No. EL/11.5.5/21

Modification Sheet No. RDSO/2024/EL/MS/0505 (Rev. '1')**1.0 Title:**

Acknowledgment method of VCD through hand operated push-button switch to eliminate possibility of rhythmic operation of foot operated switch.

Existing arrangement as per MS 505 Rev. '0'

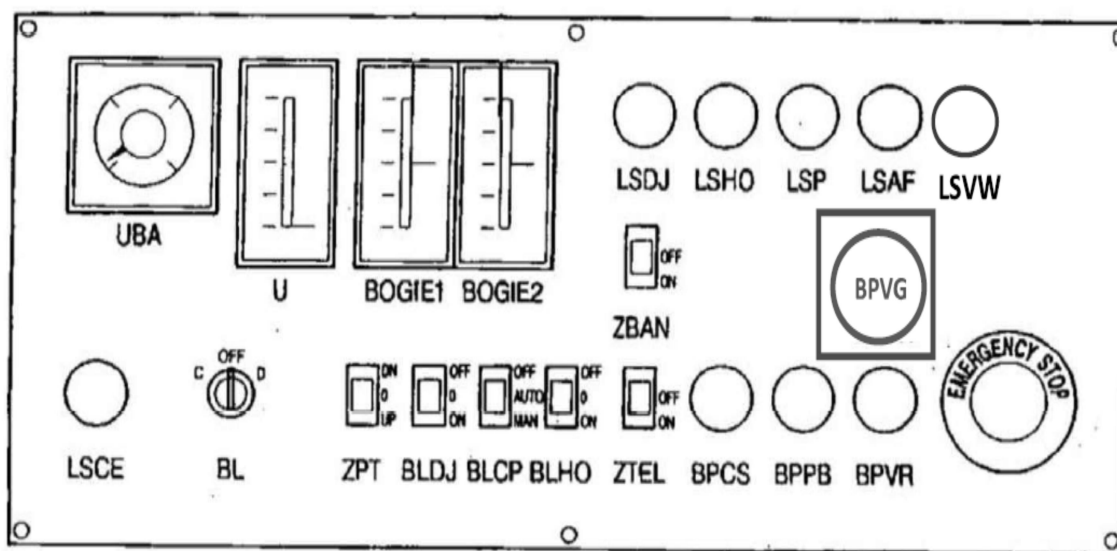
4.0 Existing arrangement:

In the existing scheme VCD is being acknowledged by foot operated switch (PVCD).

**Proposed location for three-phase locomotives****Modifications steps:**

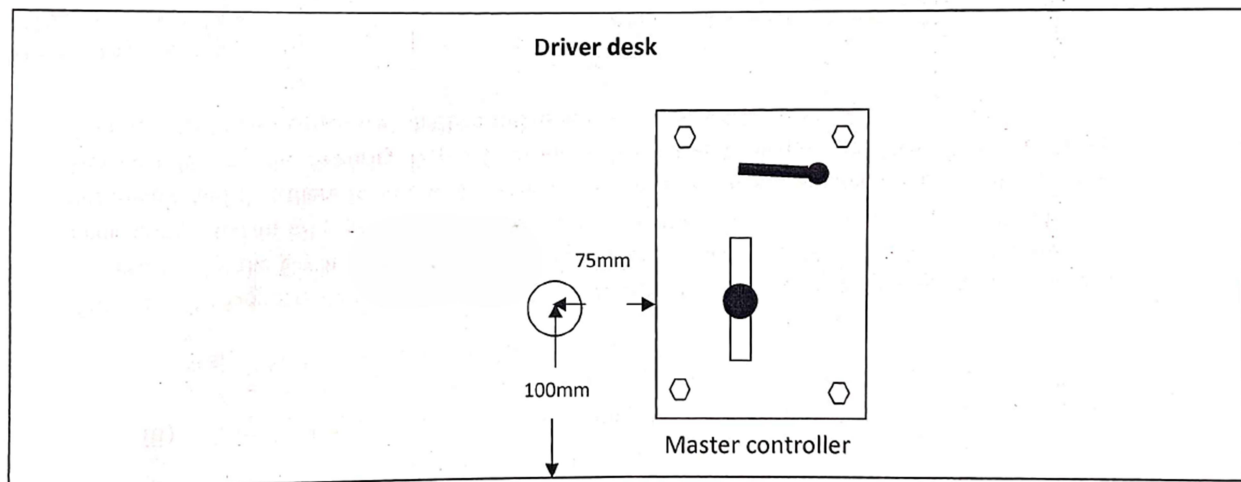
- i. **For Three-phase electric locomotives:** attached at Annexure-I.
 - a. In the modified Scheme foot operated switch (PVCD) will be removed.
 - b. LSVW is to be restored back to its original position, as it was previously shifted to the vacant space on the right hand side of LSAF in the existing scheme (Rev. '0').
 - c. New hand operated mushroom head push button switch (BPVG) to be removed from 'A' panel (as per existing scheme (Rev.'0')) and to be provided in the horizontal plane of driver desk nearer to Angle transmitter.
 - d. Existing BPVR switch having single NO interlock to be provided with one additional NO interlock i.e. total two NO interlock for both cabs.

- a) Remove existing PVCD switch and related cable to be tapped both side.

- b) Remove LSVW lamp from designated place on panel 'A' besides LSAF (as per existing scheme Rev.'0') and provide LSVW at panel 'A' in its original location.

- c) Remove the mushroom head push-button switch (BPVG) from the Panel 'A' (as per existing scheme Rev.'0') and provide BPVG in horizontal plane of driver desk near to angle transmitter. Provide 3 wires in Cab 1 from panel 'F' to BPVG in driver desk (4211A, 4218, 4218) and 3 cables also in Cab 2 from panel 'F' to panel 'A' (4211B, 4218, 4218). Connect additional cables 4211A, 4218 on NO Interlock (13-14) of BPVG. Existing connection may be shifted from Panel 'A' BPVG switch to Driver desk BPVG switch.

- d) Remove the BPVR push-button switch with single NO interlock and provide a new push-button switch (BPVR) with one additional NO interlock (i.e. two NO interlock) in same place on panel 'A'. Connect wire no. 4211A/4211B and 4234 on BPVR push-button switch NO interlock (13-14) and connect wire no. 4211A/4211B and 4218 on BPVR push-button switch additional NO interlock in Cab1/Cab2 respectively.
